BID ADDENDUM NO. 2

Date of Addendum: January 9, 2024
Issued for Bid Date: December 18, 2022
Client Name: Eastchester Union Free School District
Project Name: 2022 Capital Bond Project, Phase 3
SED Project No.: Anne Hutchinson Elementary School: 66-03-01-03-0-001-023
Eastchester Middle / High School: 66-03-01-03-0-003-031
MEMASI Project No.: 102-2301
Contracts: Contract No. 1 – General Construction (GC)
Contract No. 2 – Mechanical Construction (MC)
Contract No. 3 – Electrical Construction (EC)
Contract No. 4 – Plumbing Construction (PC)

MECHANICAL PART PLAN - 2ND FLOOR - AREA C

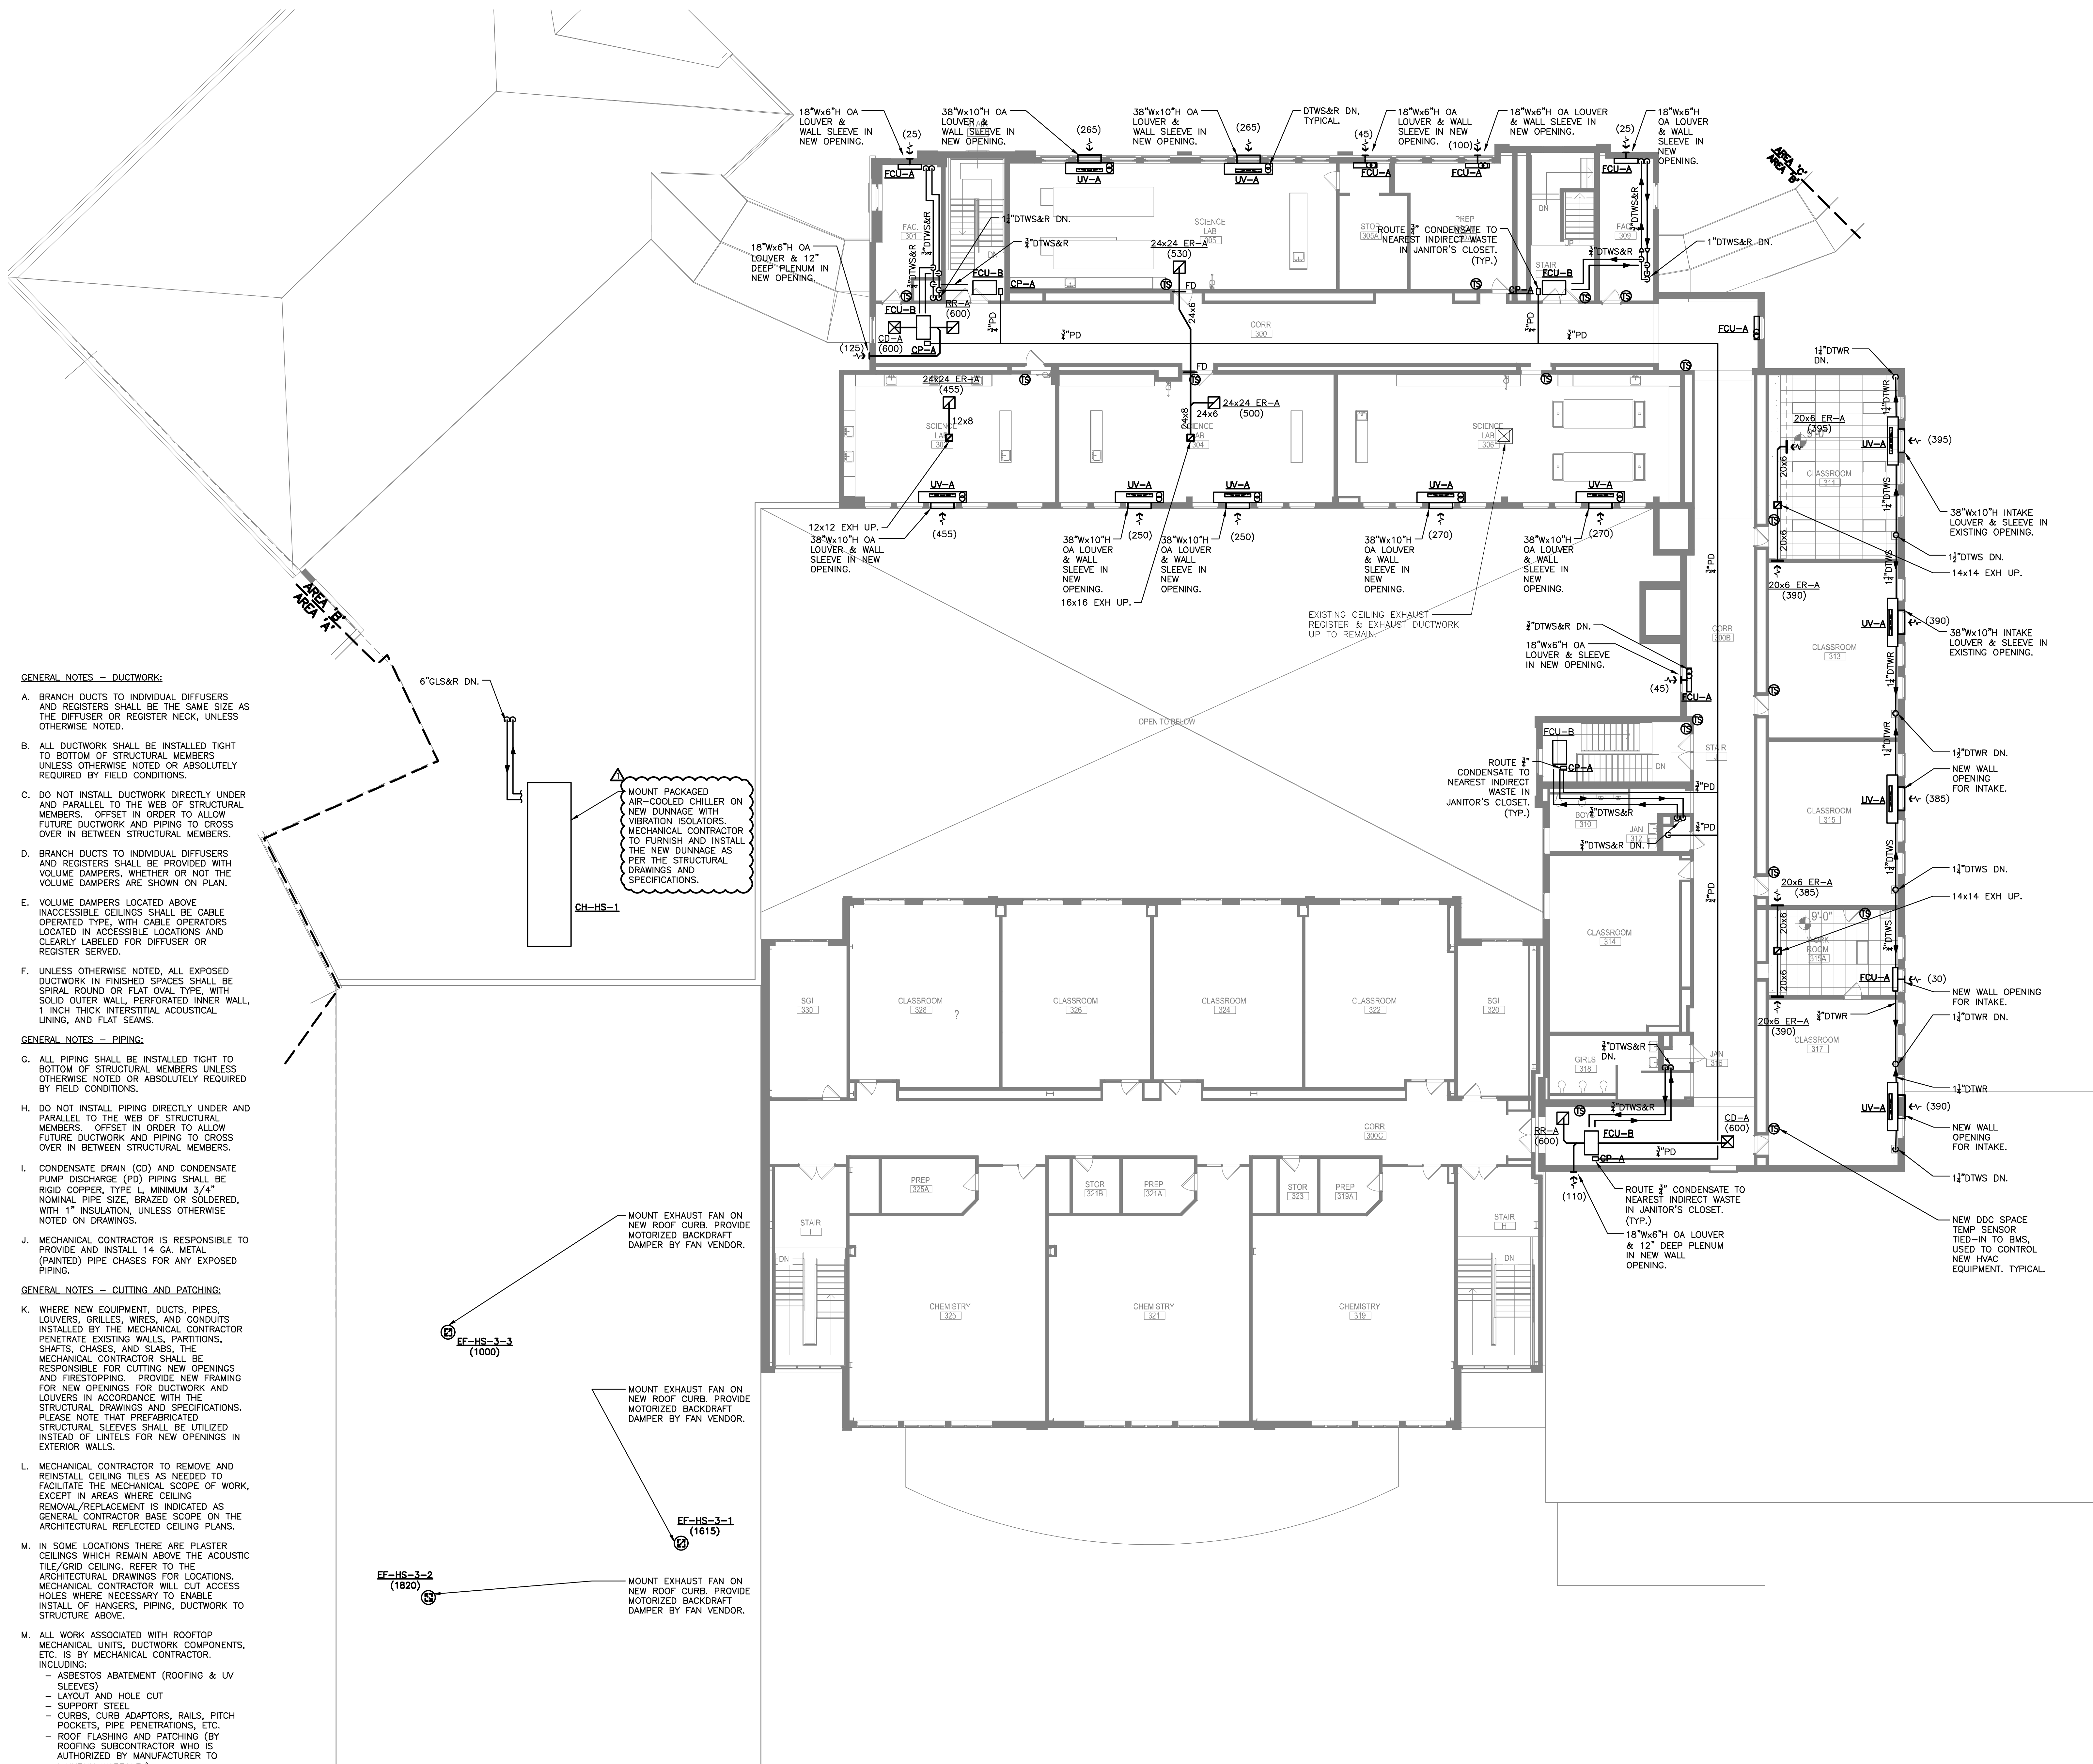
- a. Updated RTU note to indicate roof curb in lieu of dunnage. Fixed note and designation for new unit heater.
- 11. HSMS M103-B – MECHANICAL PART PLAN – 3RD FLOOR – AREA B**

**ELECTRICAL PART
PLAN - DEMOLITION -
2ND FLOOR - AREA C**

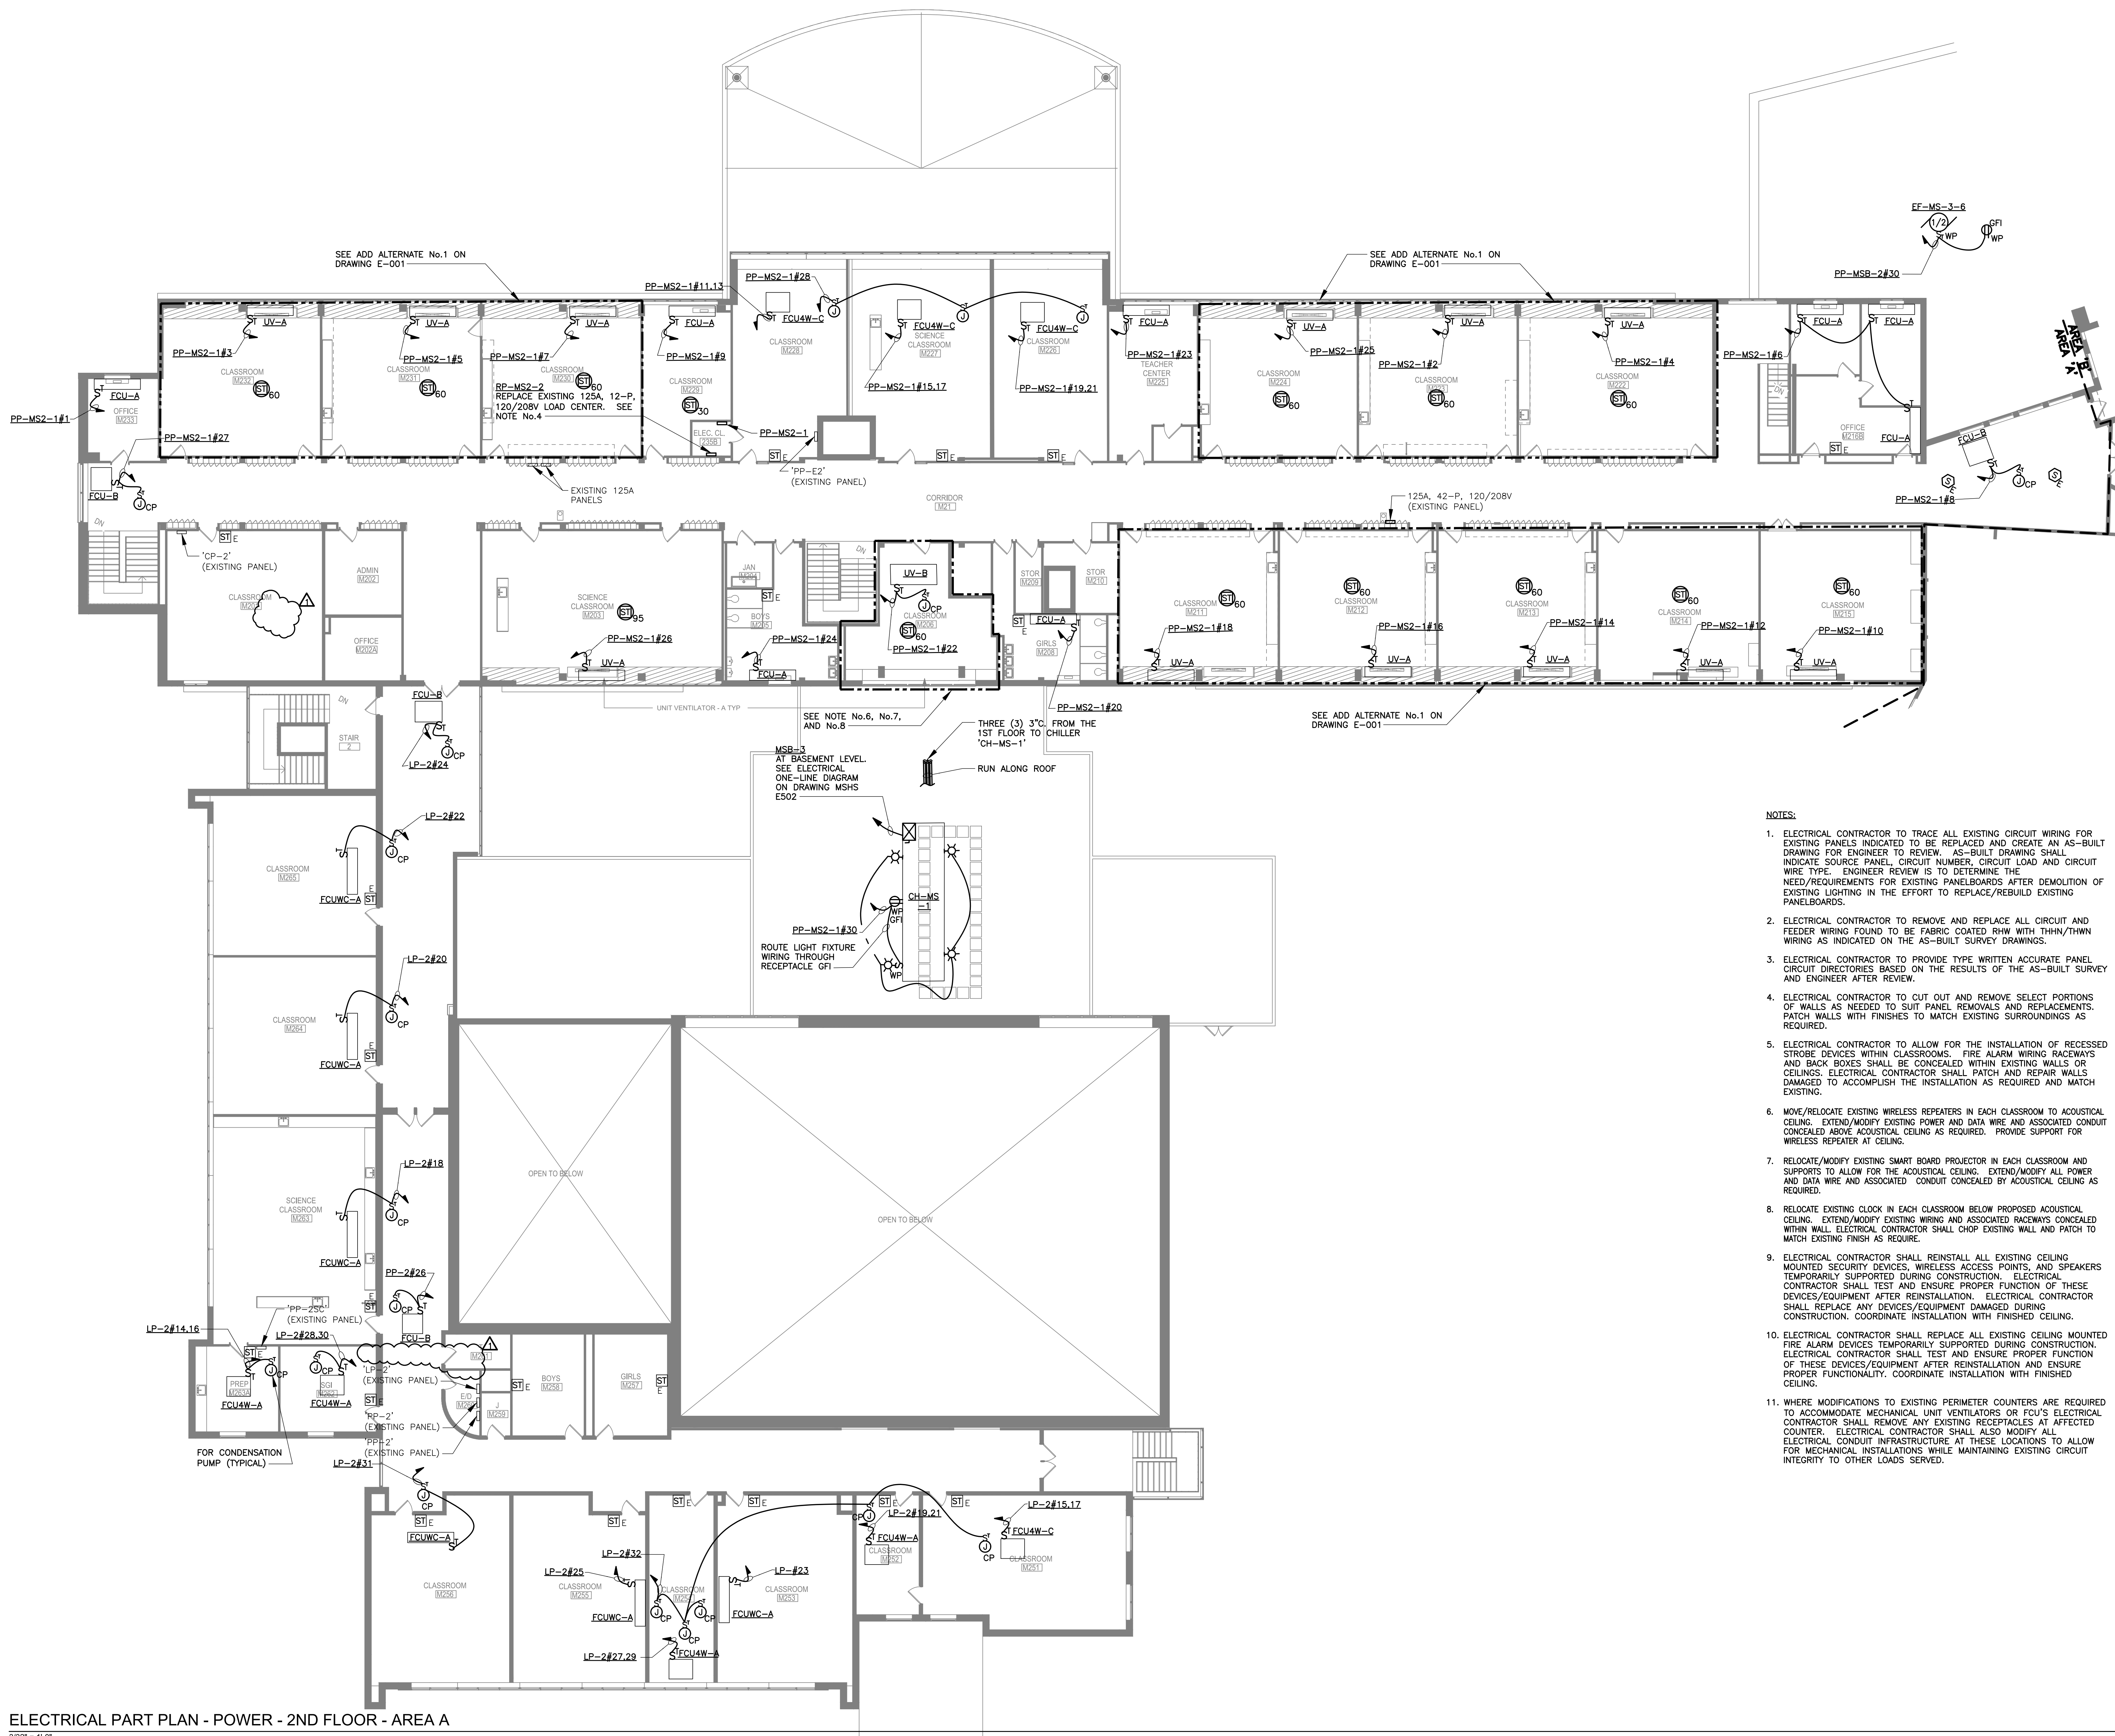
2. MSHS ED102C – ELECTRICAL PART PLAN – DEMOLITION 2ND FLOOR – AREA C

- a. Addition of this drawing.

**ELECTRICAL PART
PLAN - POWER - 2ND
FLOOR - AREA A**

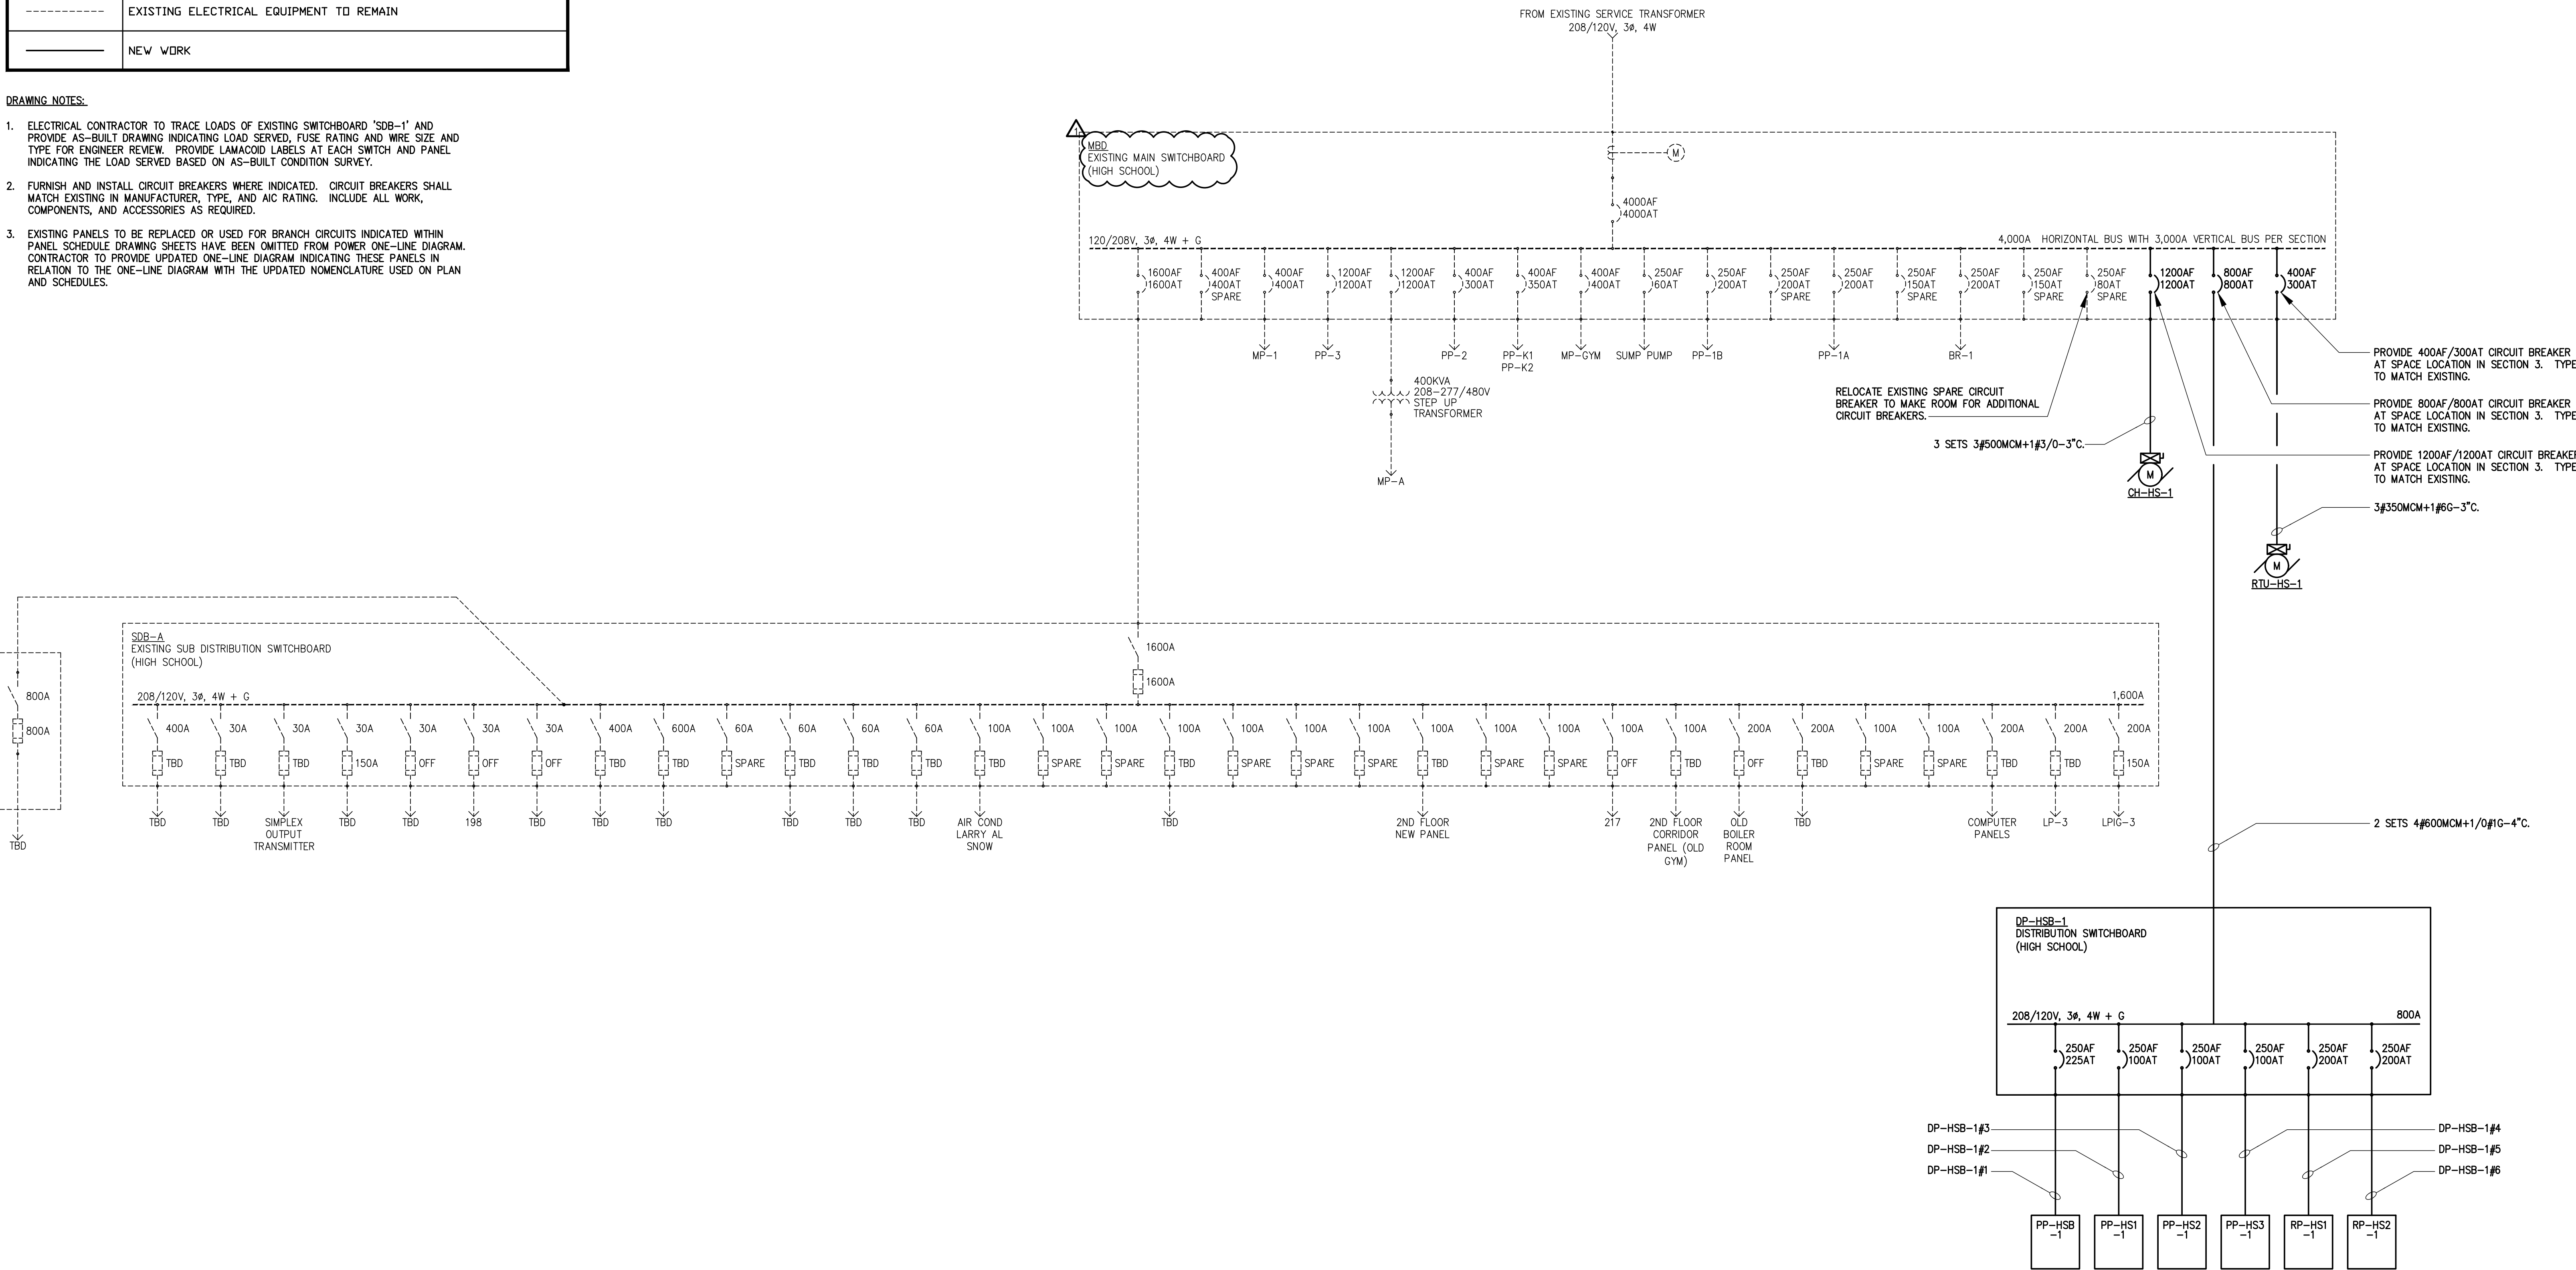
3. MSHS E102-A – ELECTRICAL PART PLAN – 2ND FLOOR – AREA A

- a. Removed a redundant ceiling fire alarm strobe.

Panel PP-MS2-2 shown on drawing MSHS-E102A has no associated panel schedule with this panel. Please provide a panel schedule and the intended scope for this panel.
